Re: Supplement to Statement of the Issues for Hearing on the Permit Application for the Proposed Gregory Canyon Landfill

EPHEMERAL DRAINAGE FEATURE COMPENSATION PLAN FOR THE GREGORY CANYON LANDFILL PROJECT

Figure 25. Perimeter drainages and drainage swales.

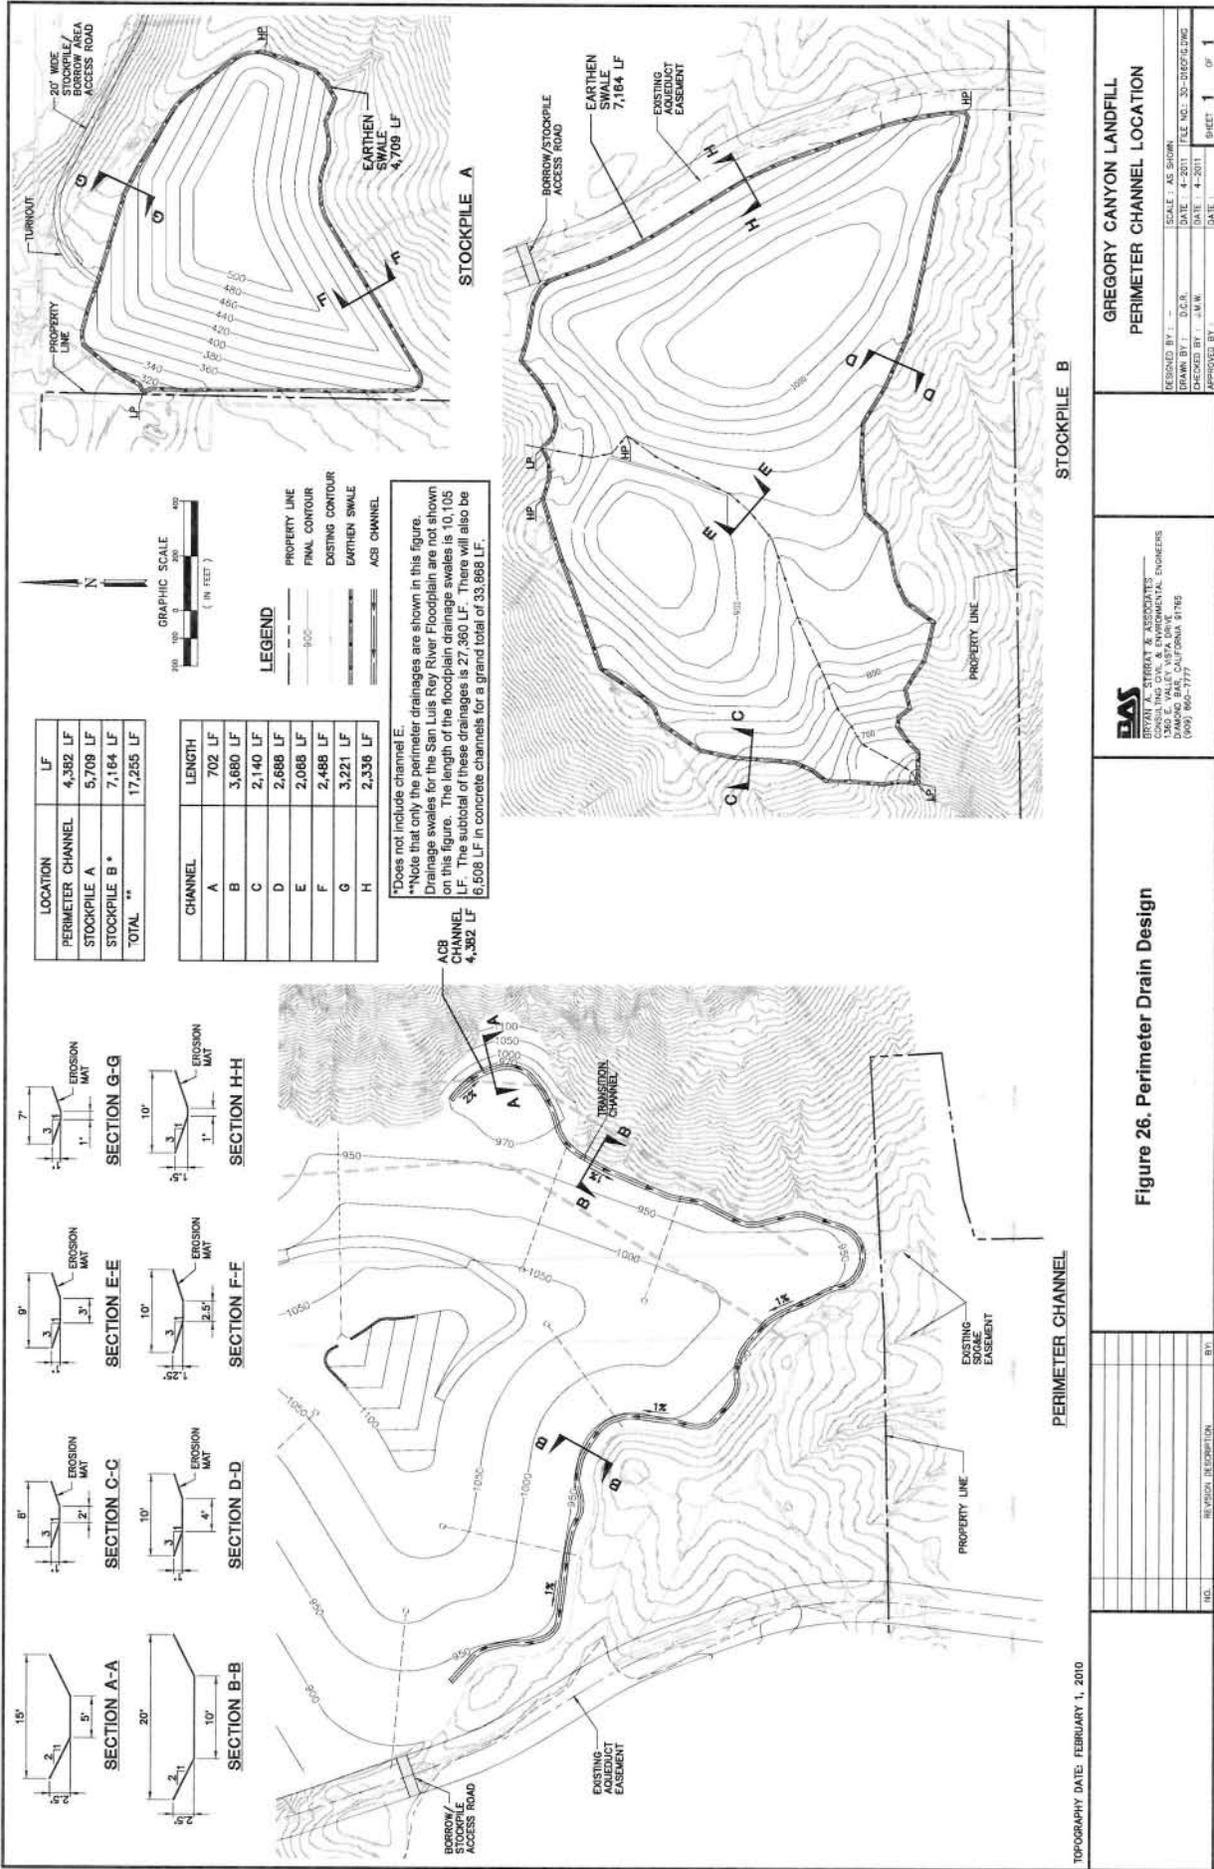
In addition, the Report states that 4,382 feet of the eastern and western perimeter drainage channels no longer would be constructed as solid concrete structures as described in the JTD, but rather would be built from “articulated block.” The Report does not describe the size of these blocks or give any other information about them except to state that installing the block instead of constructing the channels with concrete as described in the JTD “will allow for infiltration of water and establishment of vegetation that is similar to the main stem and adjacent drainage features currently existing in the canyon.”

More importantly, the change to articulated-block construction of the PSD channels is not mentioned in the JTD. Based on the limited design drawings included in the Report, it appears that the articulated block section of the perimeter channels might be wider but shallower than the perimeter channels identified in the JTD Drawing 21, but that is not clear. Also, the Report appears to indicate that flows collected in the southern part of the eastern perimeter channel actually would flow south around the southern end of the canyon and into the western perimeter drainage channel to the western desilting basin. The limited discussion in the JTD appears to indicate that water collected in this section would flow to the eastern desilting basin.
